UNITED STATES PATENT AND TRADEMARK OFFICE

APPLICATION NO.	FILING DATE	FIRST NAMED INVENTOR	ATTORNEY DOCKET NO.	CONFIRMATION NO.
10/826,311	04/19/2004	Thorsten Stabel	47481-0008-00-US	1320
55694 7590 03/01/2007 DRINKER BIDDLE & REATH (DC) 1500 K STREET, N.W. SUITE 1100 WASHINGTON, DC 20005-1209			EXAMINER ADDISU, SARA	
			ART UNIT	PAPER NUMBER
			3722	
SHORTENED STATUTORY PERIOD OF RESPONSE		MAIL DATE	DELIVERY MODE	
3 MONTHS		03/01/2007	PAPER

Office Action Summary	Application No.	Applicant(s)	
	10/826,311	STABEL ET AL.	
	Examiner	Art Unit	
	Sara Addisu	3722

DETAILED ACTION

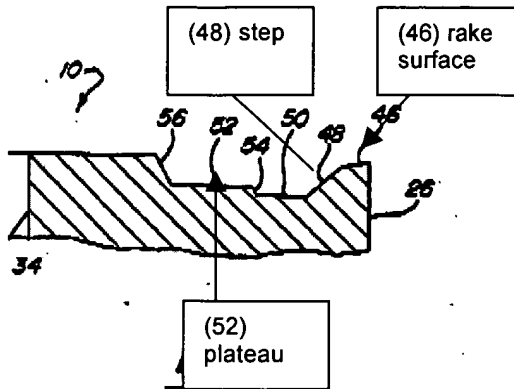
Katbi et al. teaches a cutting insert having a multi-cornered base body (square when viewed in top view, fig 2) including top and bottom surfaces (12 & 14), side flanks (26, 28, 30 & 32) interconnected by corner surfaces, cutting surface (36) on top and/or bottom surface, peripheral cutting edge (38) formed at the intersection of side flanks and top and bottom surfaces (12 & 14) (see figure 1 and Col. 2, lines 40-45). Katbi et al. also teaches the cutting surface having a central bore (34), a plateau (52: Examiner is defining it to be the plateau and since it is a support pad it defines a seating surface) surrounded by a peripheral positive rake surface (46) that is situated between the plateau surface (52) and the cutting edge (38) (see diagram below). Furthermore, Katbi et al. teaches an upwardly extending variable peripheral step (48) interconnecting the plateau (52) and the rake surface (46) (with the corner step portions extending uninterruptedly along the respective corner rake surface portions) (see figure 2, which also shows that step (48) is linear when viewed perpendicular to the cutting surface). Additionally, Katbi et al. teaches side flanks forming obtuse corners (see figure 2). Regarding claim 19, Katbi et al. teaches variable width land surface (rake) which is changes width at (44) leading to a wavy step portion around the corners (see figure 2 and Col. 2, lines 49-54). Furthermore, Examiner points out that Katbi et al. teaches the cutting edge (38: which is arched) has a descending rake (46) located rearward from the cutting edge and the descending rake face is followed by a descending step (48) ('591, figure 4 and Col. 2, lines 45-58 and 66-68). If the height of the step was constant then the step would no longer be descending towards the center of the insert but rather ascending since the rake surface just forward of it has a variable descending angle. See

figure below for further explanation (the angles are exaggerated). Katbi et al. teaches the rake face (46) having descending angle 14 degrees and narrower width (wa) at the corner and 12 degrees and a wider width (wb) towards the flank ('591, Col. 2, lines 58-60 and 51-53). As shown below, the left figure indicates corner portion where the cutting edge is at its highest height (because it's arched at the center), however the rake face has a wider descending angle and a narrower width (wa) which leads to the following portion (i.e. descending step, 48) to start descending from a higher location to plateau 52. On the other hand, the right hand figure represents the flank area such as the center where the cutting edge is at its lowest height (because it's arched at the center), however the rake face has a smaller descending angle and a wider width (wb) which leads to the following portion (i.e. descending step, 48) to start descending from a lower location to plateau 52, thus there is a height difference (ha is higher than hb) (i.e. the step has a varying height, wherein a maximum height is disposed at the corner step portions, as recited in claim 1). Furthermore, Katbi et al. teaches '591, Col. 2, lines 60-65) that "Those skilled in the art recognize that any angles can be used as the first variable descending land angle so long as the first variable descending land angles at the corners of the insert are greater than the first variable descending land angle of the surface along the flanks of the insert", therefore the selected angles would determine how substantially height difference there should be. Examiner points out that given the fact that inserts are small in size, even if the angle difference is small, there is a height difference which may be considered "substantial" in a unit of measure such as micrometer.
